TRCA CORRESPONDENCE WITH REGARDS TO SANITARY & STORM WATER MODELING

Subject: LCH Condo Proposal and concerns of possible impacts to Doris McCarthy Trail

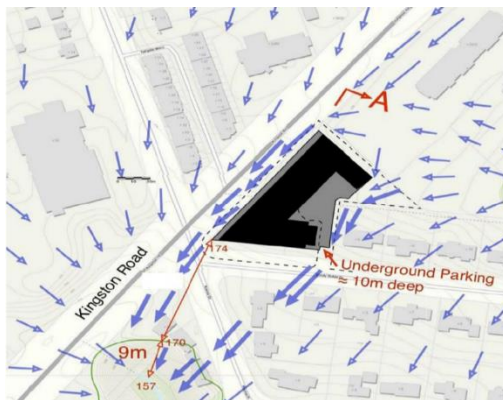
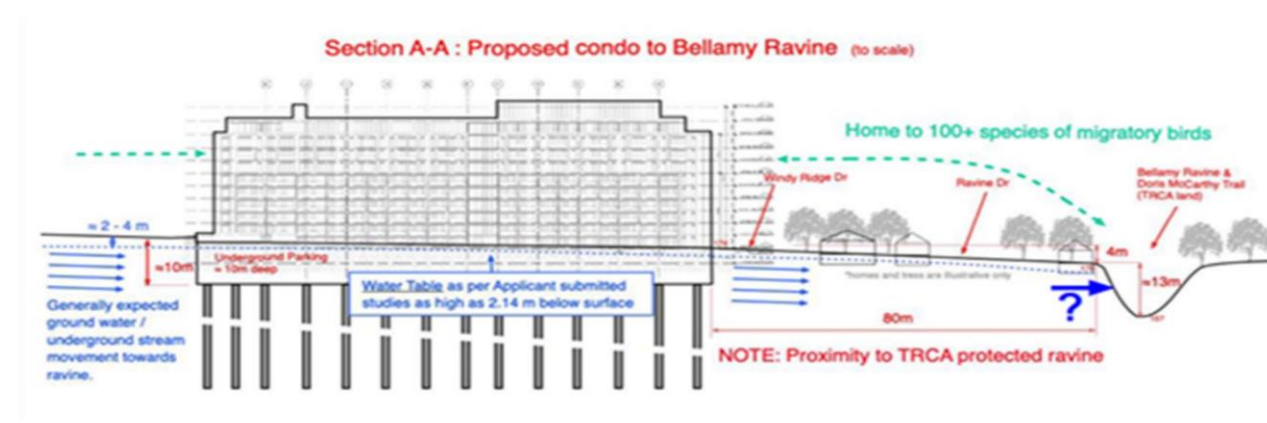
3. Are the attached diagrams generally plausible or what could be expected given the contours of the land?
Attached are diagrams I have been developing to serve as visuals for the issue of groundwater rerouting from the condo garage and proximity of this large scale condo to the Ravine and migratory birds. The topology (contour lines) are from the city maps.

I added the blue arrows based on the slopes indicated on the map to show likely above and below ground water flow. The section is to scale based on map measurements and heights from the maps and the LCH architectural plans. Some additional research found that the area is environmentally sensitive and the City has deemed the area a heritage environment and also a critical part of the green space corridor through the south Scarborough area.

Without question, the condo will affect water flow through the property and around it. It will most certainly affect water flow beneath it. It appears there will be a large catchment system beneath the building to capture and redirect water to a subgrade water management system. With this, the redirection of water below grade may not be measurable nor realized for a significant time period. It may not affect the immediate properties in the manner we may assume if there are measures to control the water flow. There are a multitude of maps here on this city site here:

Regarding some of your other comments, it is correct that groundwater and localized surface runoff will generally be directed towards Bellamy Ravine. The sanitary sewer information you are requesting is something that Toronto Water from the City of Toronto would have to provide to you and not TRCA. I'd suggest contacting 311 to request additional details about the capacity of the existing infrastructure.
